PLANNING COMMISSION

AGENDA

1.	PUBLIC HEARINGS: 7:05 p.m. – RESOLUTION NO. 11-16 Review and action upon a request by Ivory Development represented by Nick Mingo for a recommendation to the City Council to consider the Final Plat for Phase 6 of the Cranefield Estates Subdivision located at approximately 3550 West 2350 North.

SUBJECT: 7:05 p.m. – PUBLIC HEARING – RESOLUTION NO. 11-16 Review and action upon a request by Ivory Development for a recommendation to the City Council to consider the Final Plat for Phase 6 of the Cranefield Estates Subdivision located at approximately 3550 West 2350 North.	AGENDA ITEM: 1		
PETITIONER: Nick Mingo, representing Ivory Development	MEETING DATE: August 2, 2016		
ORDINANCE REFERENCES: Subdivision Ordinance Engineering Standards and Specifications Zoning Ordinance Chapter 12 – A-1 Zone and the now deleted Chapter 7 Planned Development (PRUD/PUD) Overlay.	ROLL CALL VOTE: <table style="margin: auto; border: none;"> <tr> <td style="padding: 0 10px;">X YES</td> <td style="padding: 0 10px;">NO</td> </tr> </table>	X YES	NO
X YES	NO		
BACKGROUND: The Master Land Use Map in the General Plan shows this area zoned for residential use with the land use desi

- Submittal Date: 5/13/2016

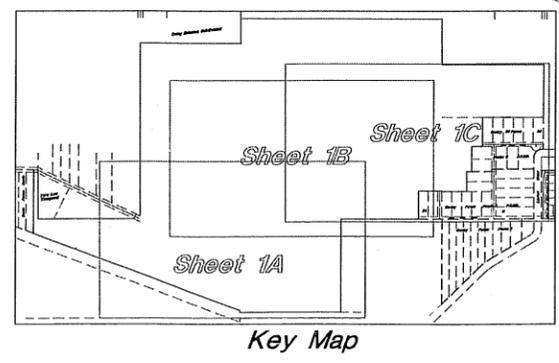
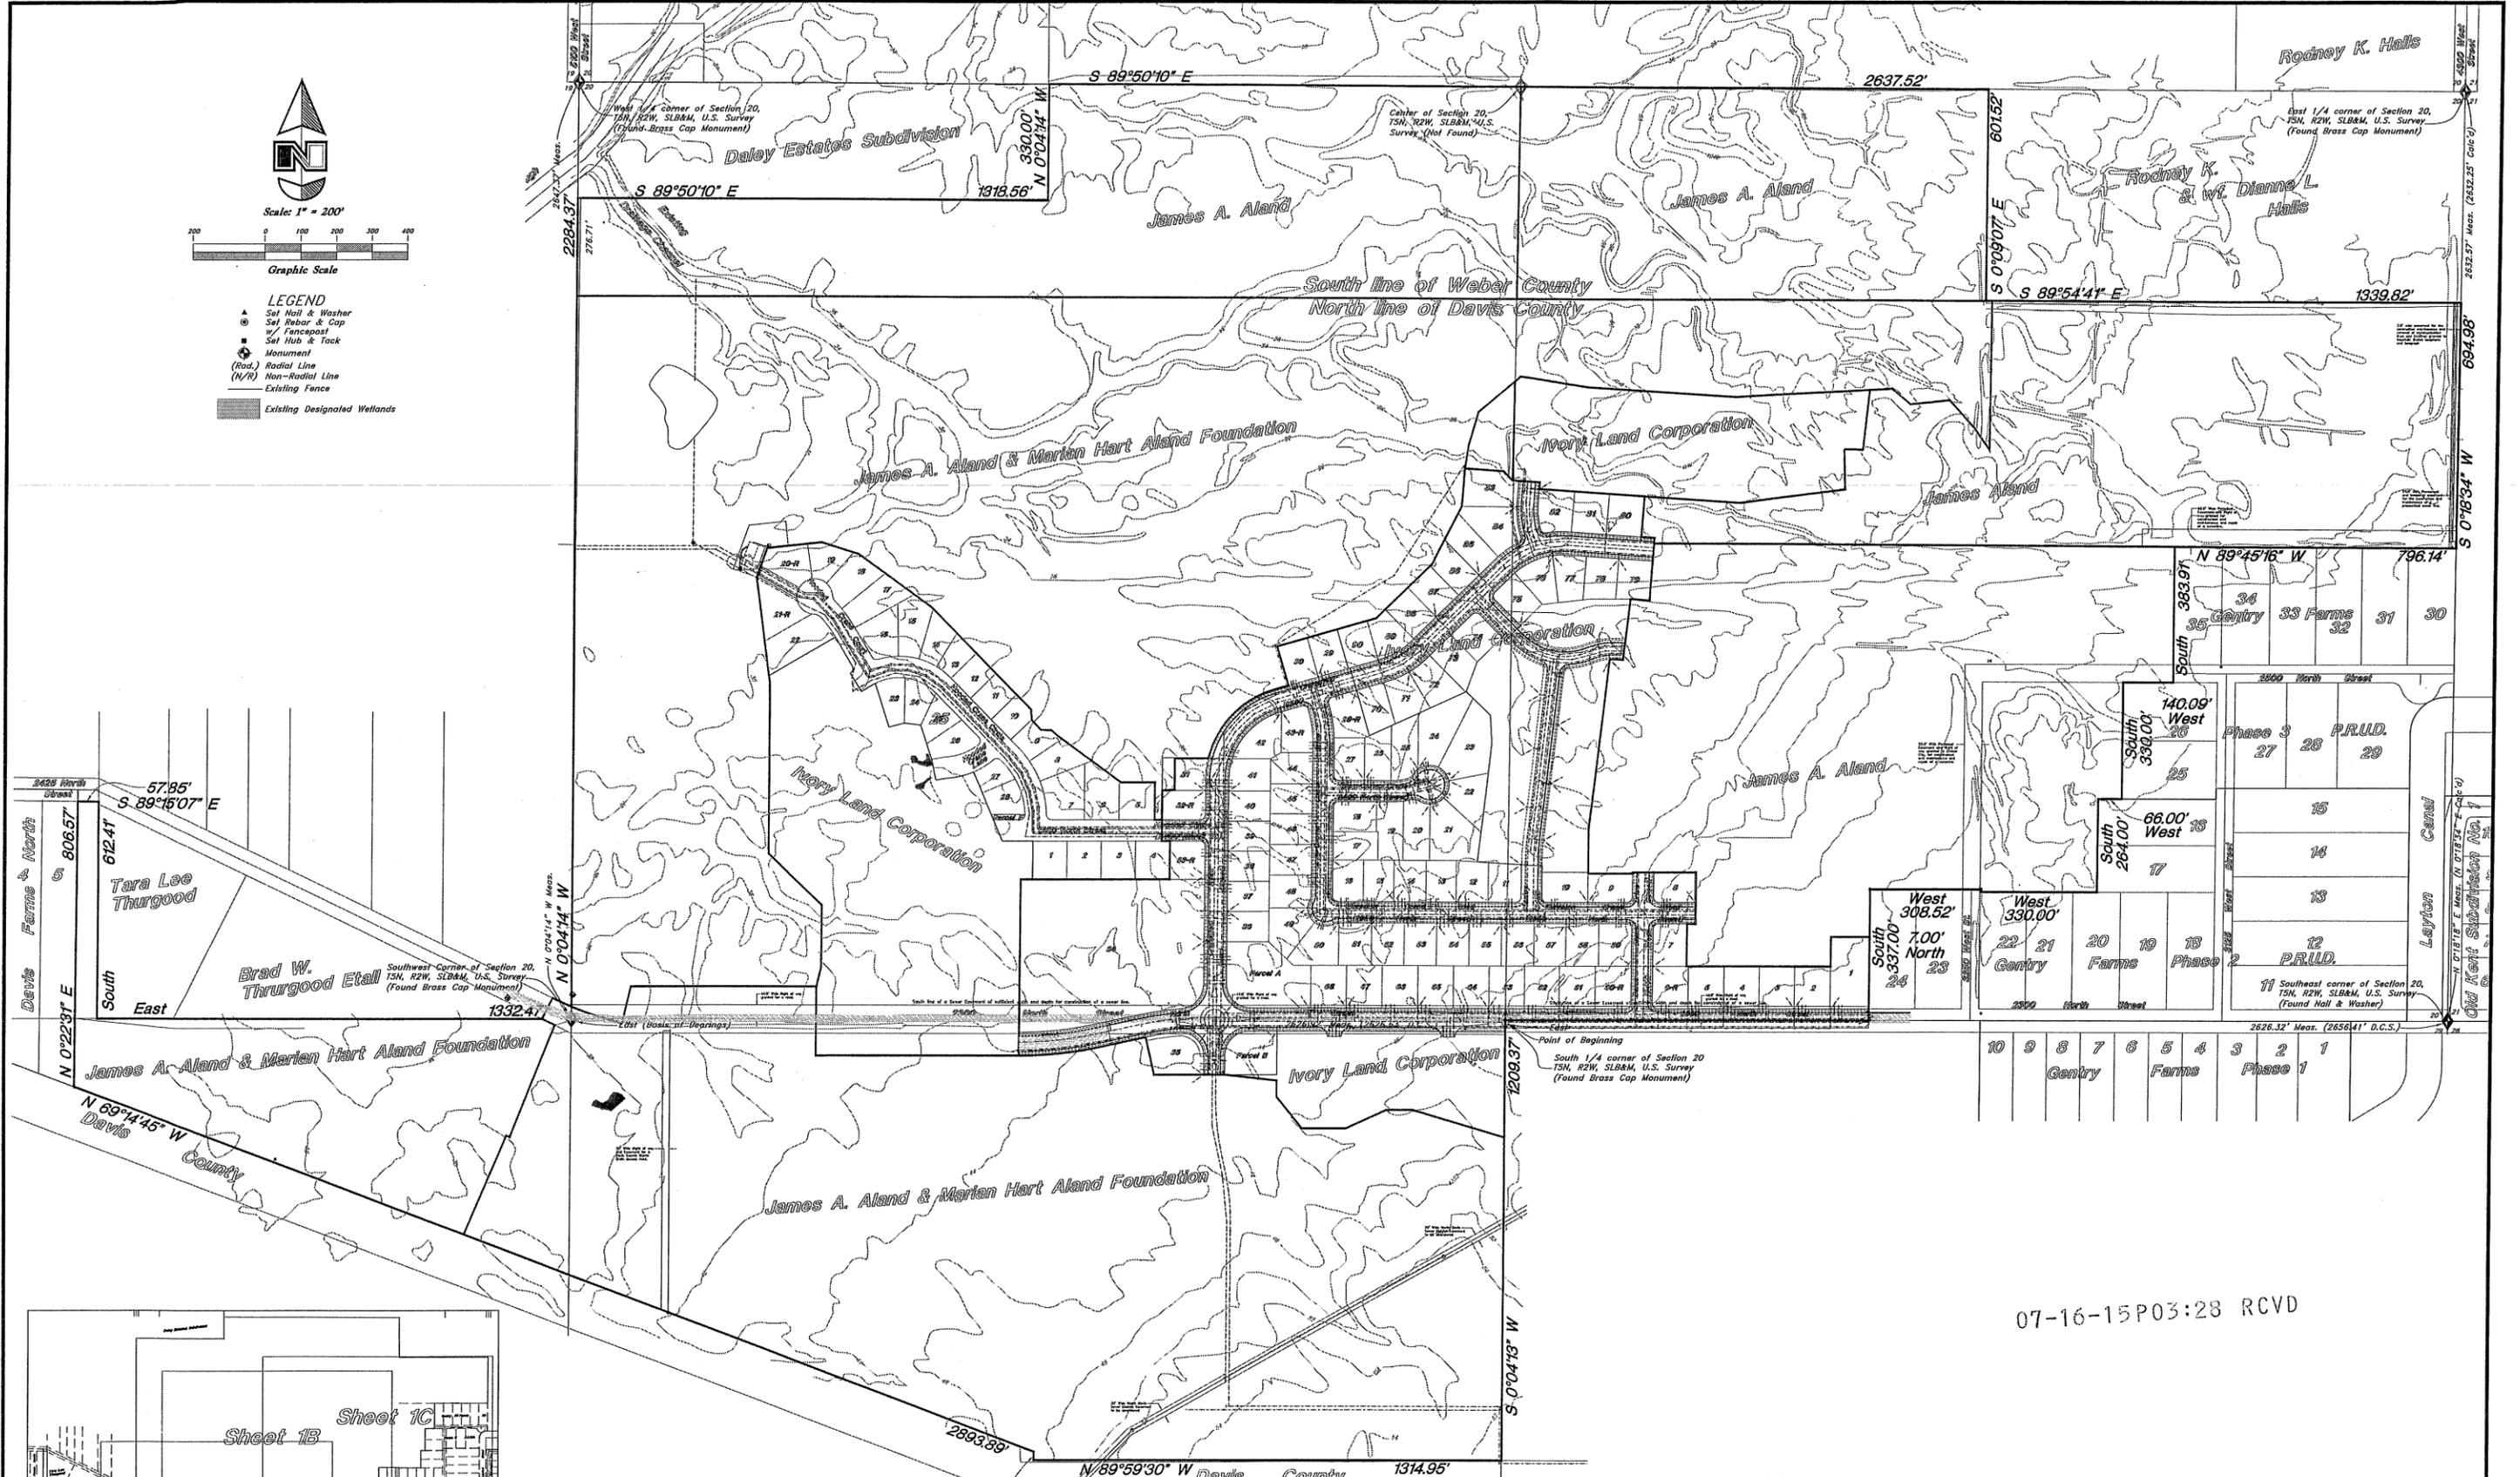
The developer shall be responsible to grade each lot such that runoff water is directed to fronting roads. Grading shall ensure that the runoff from each lot does not drain onto neighboring lots or properties.

- Fire Hydrant locations: lot 146(SE), between lots 154-153(2400N)
- Submit SWPPP, plan must be approved before a pre construction meeting can be scheduled
- Add restriction to lots 150-154, no access allowed to 2400N
- No waterline details, show valve locations, fire hydrant valves located on the mainline connection
- Adjust alignment of LD, S, W, and Irrigation so they do not overlap each other
- Update standard street design to match pavement design from the geo tec report
- Note contractor to install all traffic and address signage to MUTCD spec's
- Identify signage locations
- Identify blow offs and caps on the dead end 2400N
